ITS CORPORATION				REV	ECN	DATE	APV
THIS PRINT IS THE PROPERTY OF ITS CORP IT SHALL NOT BE COPIED WITHOUT PERMISSION				TITLE SCHEMATIC, VARIABLE PHASE/GAIN BD. (1245-1201)			
MATERIAL ----				DWN	DD	4/30/96	DWG. NO.
FINISH ----				CHK	JAG	5/16/96	1245-3201
				REL	JAG	5/16/96	C
				SCALE		SHEET 1 OF 1

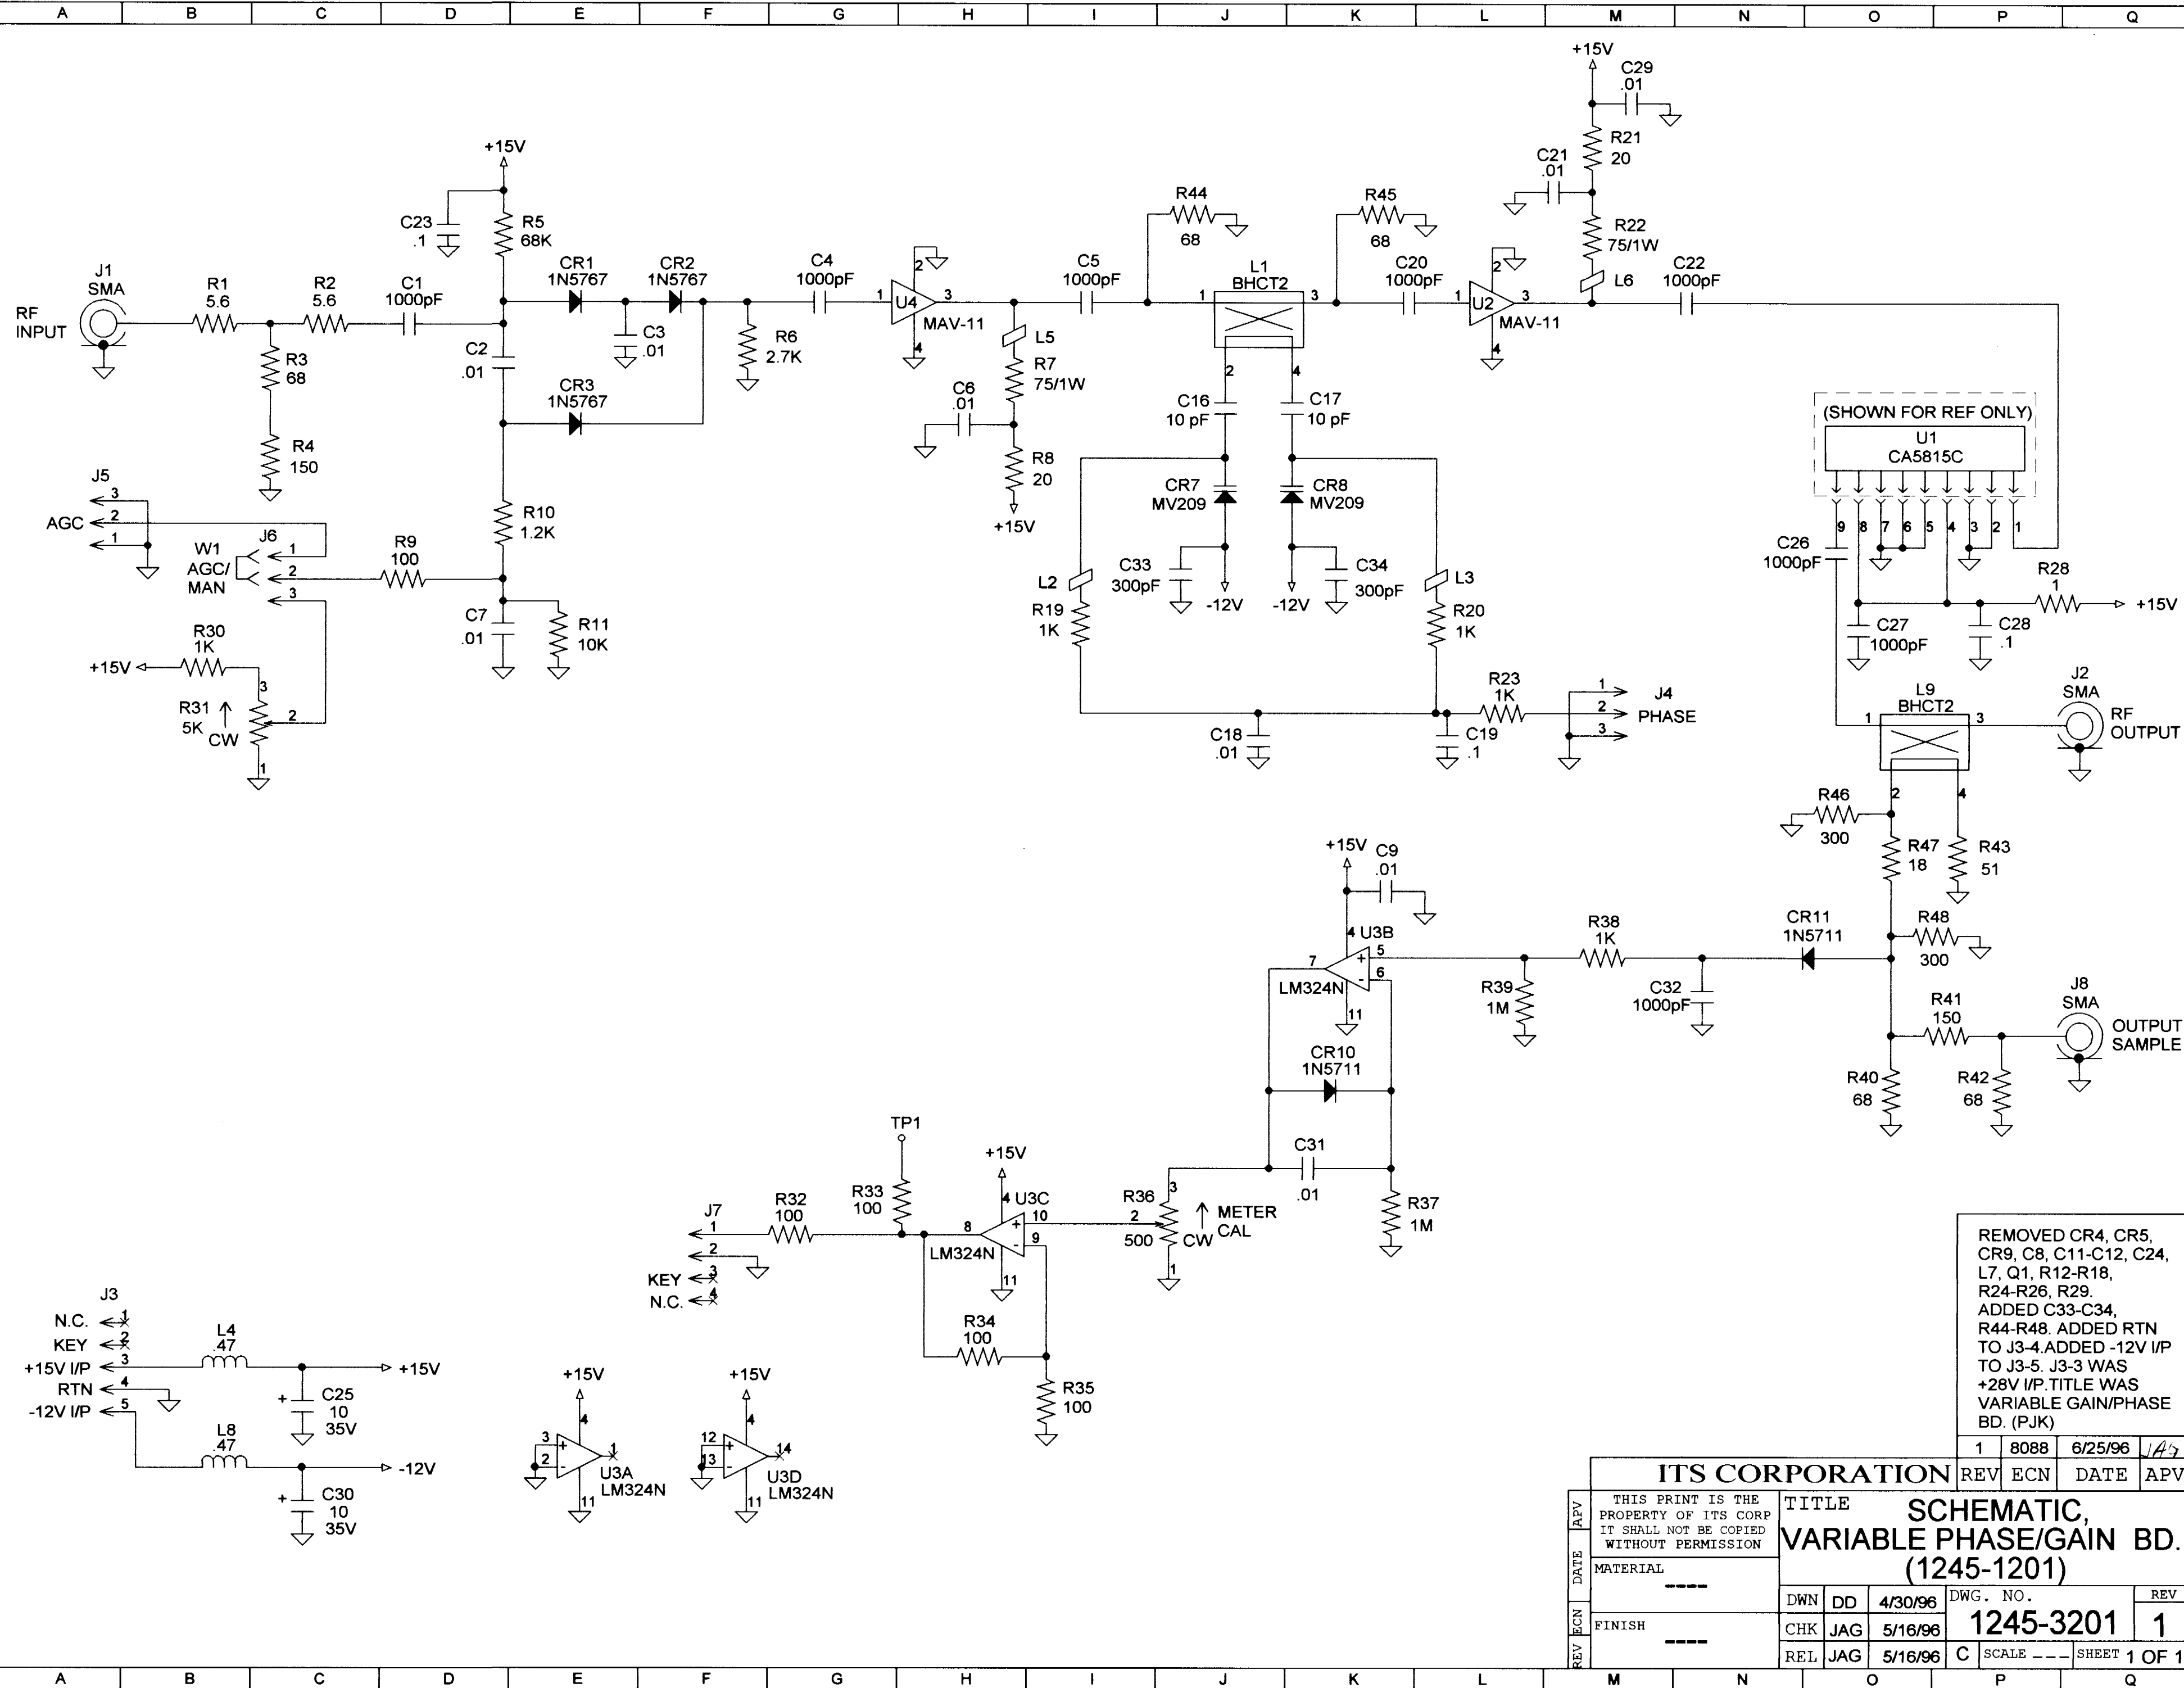
REMOVED CR4, CR5,
CR9, C8, C11-C12, C24,
L7, Q1, R12-R18,
R24-R26, R29.
ADDED C33-C34,
R44-R48. ADDED RTN
TO J3-4. ADDED -12V I/P
TO J3-5. J3-3 WAS
+28V I/P. TITLE WAS
VARIABLE GAIN/PHASE
BD. (PJK)
